## The RadioActivist Campaign

Comment: to the Blue Ribbon Commission (BRC) of the DOE

Title: **Concern for unassessed, local failure of a repository in salt**

July 21, 2010

**Fig. 5. Mean total risk probability of release R** [from Nelson, p. 18].

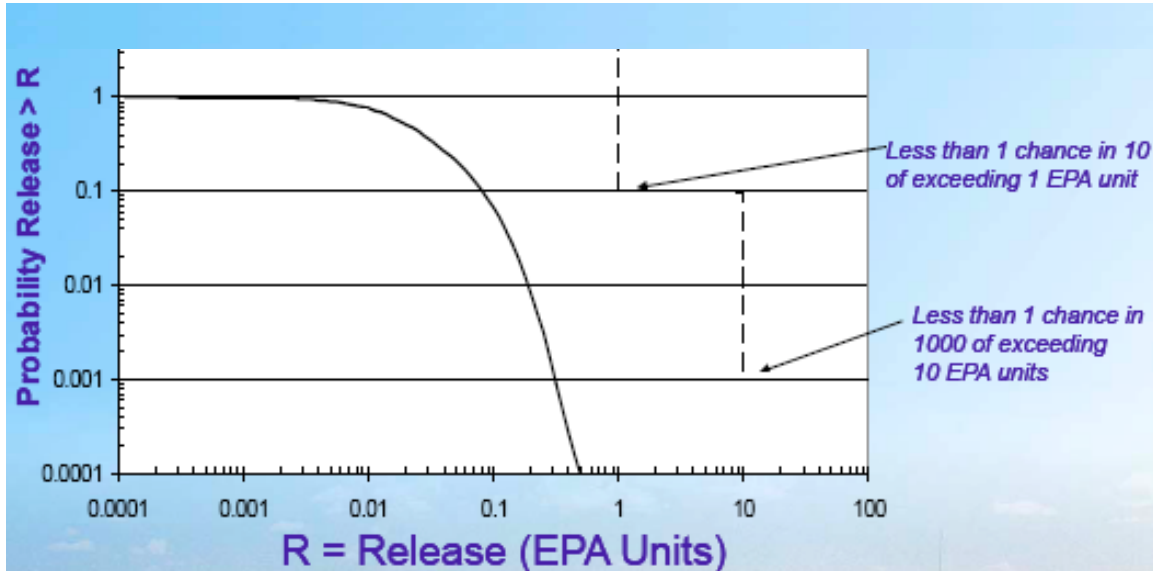
The risk models show that probabilities of releases from Undisturbed Performance (no human intrusion) of the repository are below concern; that is, total risks for all undisturbed scenarios are to the left and below the area shown in Fig. 5. Thus, WIPP claims "no release" from any and all scenarios not involving human intrusion [Nelson, p. 22].

Notice the steep slope of the total risk probability curve, close to the upper step of the EPA Containment Requirements, on the right of Fig. 5. This steep slope means that adequacy of containment is much more sensitive to the magnitude of modeled release than to the modeled probability of a release occurring.
